18 REPORTS FROM OFFICERS – PLANNING AND INFRASTRUCTURE DIRECTORATE

18.1 629-639 PACIFIC HIGHWAY, CHATSWOOD - PLANNING PROPOSAL

MEETING DATE: 12 FEBRUARY 2018

Figure 8

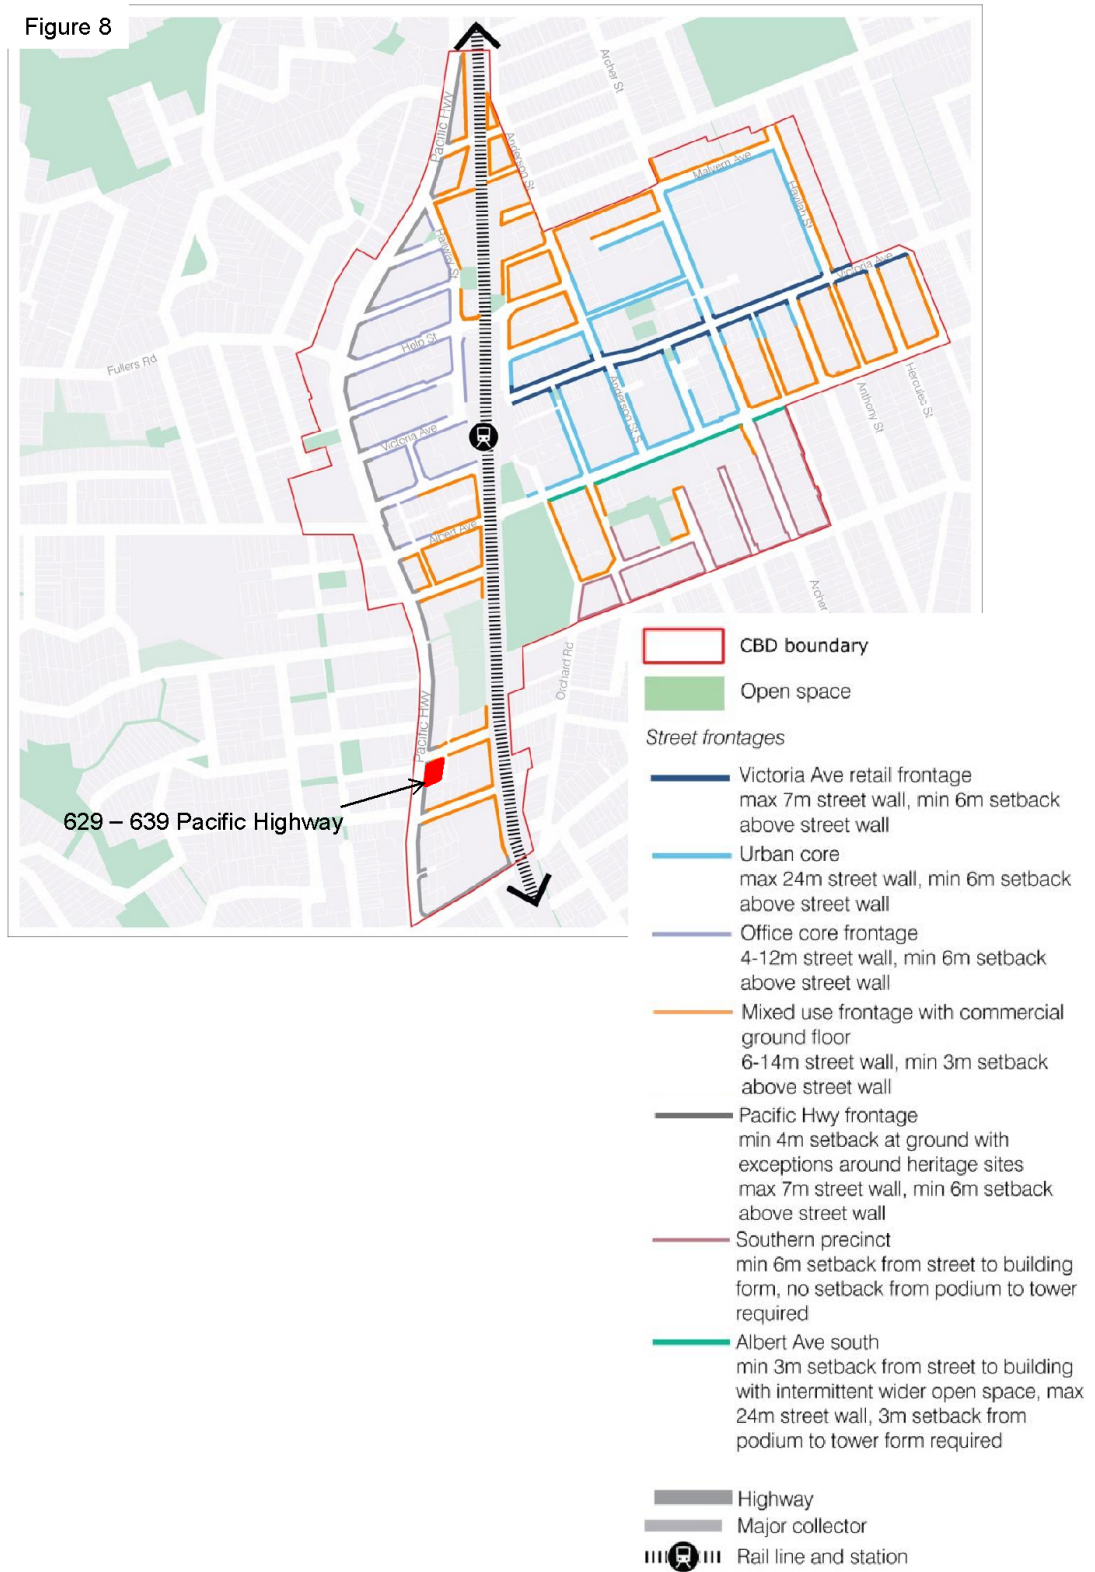
The December 2017 Concept Plans are consistent with the above Figure 8 requirements applying to the subject site, with one variation:

“Commercial floor space is required to provide significantly higher floor to ceiling heights than is the case for residential floor space. A floor to ceiling height clearance of 4.2m is required for the ground floor and 3.6m for the first floor level, resulting in a minimum podium height of 7.8m. It is requested that Council allow for a maximum podium height of 8m to ensure appropriate floor to ceiling height clearances.”

Based on the satisfactory addressing of setback requirements, the reduced impact of a two level Podium across the site and the importance of a viable commercial component of this mixed development, it is deemed reasonable to forward the Planning Proposal with this variation to the Gateway for further consideration.

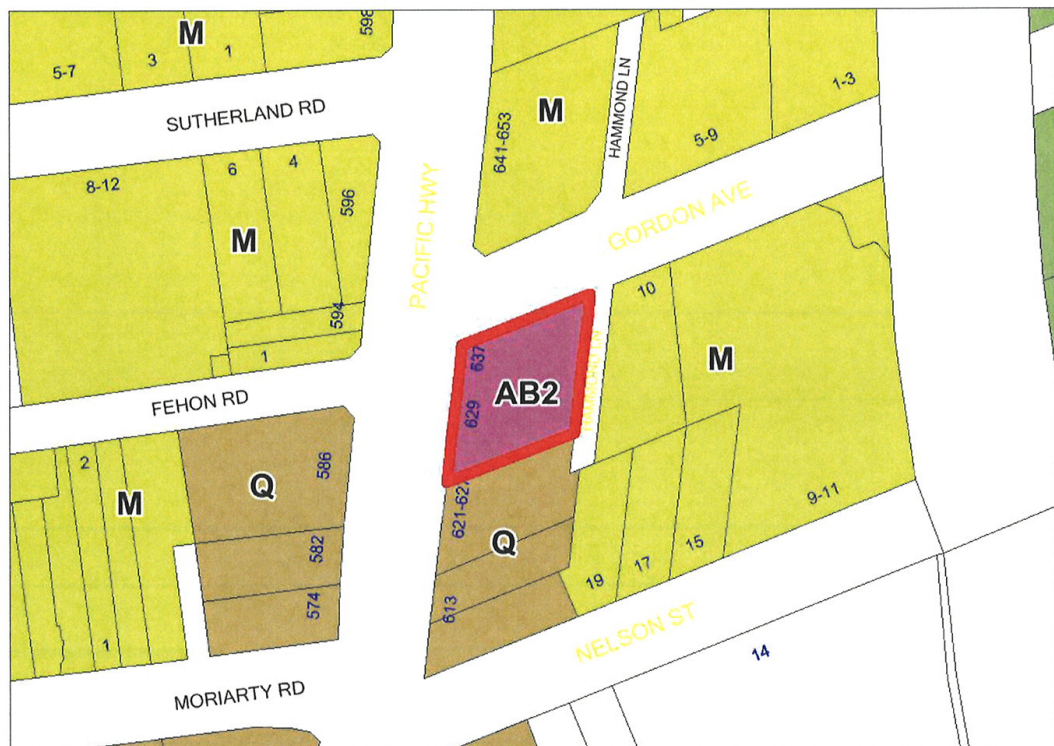
- d) To amend the Land Zoning Map (Sheet LZN_004) for 629 – 639 Pacific Highway, Chatswood, to B4 Mixed Use.
- e) To amend the Height of Buildings Map (Sheet HOB_004) for 629 – 639 Pacific Highway, Chatswood, to 90 metres.

HOB: AB2 (90m)

FLOOR SPACE RATIO MAP

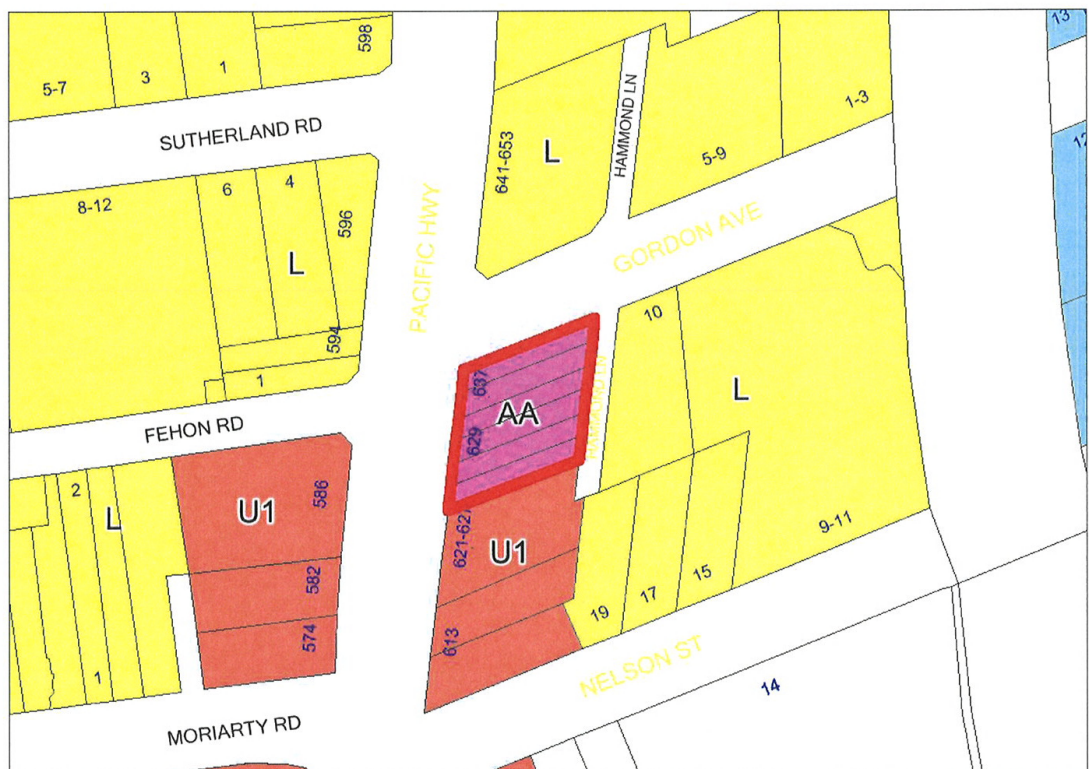
- f) To amend the Floor Space Ratio Map (Sheet FSR_004) for 629 – 639 Pacific Highway, Chatswood, to 6:1 (including affordable housing).
- g) To amend the Special Provisions Area Map (Sheet SPA_004) to show 629 – 639 Pacific Highway, Chatswood, as Area 8.

FSR: AA (6 : 1)
